Integrated Issue Resolution Status Report

**U.S. Nuclear Regulatory Commission
Office of Nuclear Materials Safety and Safeguards
Washington, DC 20555-0001**

Integrated Issue Resolution Status Report

Manuscript Completed: April 2002
Date Published: July 2002

Figure 2.1.6-4. Overview of the DOE Proposed Classification Process¹²

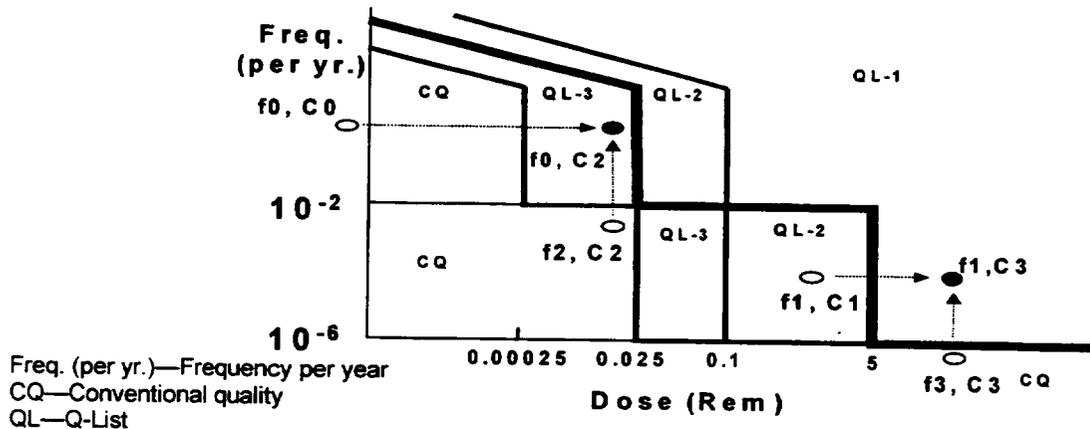
The DOE Q-List (2000) does not include all structures, systems, and components used in the geologic repository operations area. The DOE Q-List of structures, systems, and components and quality level characterization are based on the current system design described in several system description documents. 10 CFR 63.112 requires that the preclosure safety analysis of the geologic repository operations area identify those structures, systems, and components important to safety and also identify controls relied on to prevent potential event sequences or mitigate their consequences. DOE should consider all structures, systems, and components used in the geologic repository operations area to identify those important to safety. For example, shield doors and isolation doors, described in assembly transfer, canister transfer, disposal container handling and subsurface facility system description documents (CRWMS M&O 2000d-g), are not included in the Q-List. DOE should provide acceptable justification for

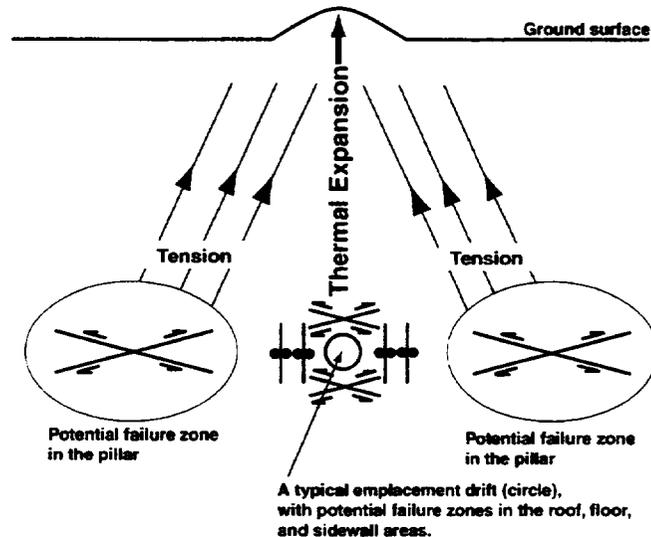
As illustrated in Figure 2.1.7-1 (Ofoegbu, 2001) and discussed in the foregoing paragraph, the effect of geometry on thermally induced stress depends to a large extent on the location of a mechanically free boundary, such as the ground surface. The topography of Yucca Mountain (e.g., Section 2.1.1) is such that the distance to the closest free surface and the orientation of the direct line from an emplacement drift to the free surface vary over the proposed emplacement area. For example, a typical east-west vertical section through Yucca Mountain (e.g., DOE, 2001a, Figure 1-10) indicates that the direct line from the emplacement area to the closest free surface would be inclined approximately 45 degrees to the vertical in the west (where the closest free surface is the Solitario Canyon) but would be nearly vertical in the east. Therefore, the orientation of the thermally induced tension in Figure 2.1.7-1 would vary over the emplacement area. For this reason, the topography of Yucca Mountain may have an important effect on the distributions of thermally induced stress and potential failure zones within the proposed emplacement area.

proposed drift alignment (252° azimuth, that is S72 °W). The ambient minimum principal stress is horizontal and oriented N60 °W–N65 °W (Stock, et al., 1985), which is 40–45 degrees from the drift-normal plane (the assumed orientation of the minimum principal stress for the two-dimensional modeling). Also, the dip direction of the subhorizontal fractures, which are likely to dominate the rock-failure mechanism as illustrated in Figure 2.1.7-1 (Ofoegbu, 2001), lies in the 40–60-degree range (i.e., 10–30 ° from the drift orientation). Therefore, the two-dimensional models are not favorably oriented to detect slip on the subhorizontal fractures. Three-dimensional modeling may be necessary to determine the effects of these structural features that are oblique to the drift alignment.

Other areas for which three-dimensional modeling may also be necessary include (i) stability of the turnout area (between the emplacement drifts and the access mains), which may be subjected to a combination of vertical tension and high-horizontal compression similar to the phenomenon illustrated in Figure 2.1.7-1 (Ofoegbu, 2001); (ii) effects of greater heat conduction rates through the drift floor because steel members in the floor (invert and pallet) that are in direct or indirect contact with the waste package provide a faster heat-flow path into the rock; (iii) stability of the structural components of the invert (transverse and longitudinal beams) and the interaction of the transverse beams with the drift wall under heated conditions; and (iv) effects of ground-surface topography drift-parallel thermal gradients on thermal stress and, consequently, drift stability. DOE has agreed⁸ to address this concern.
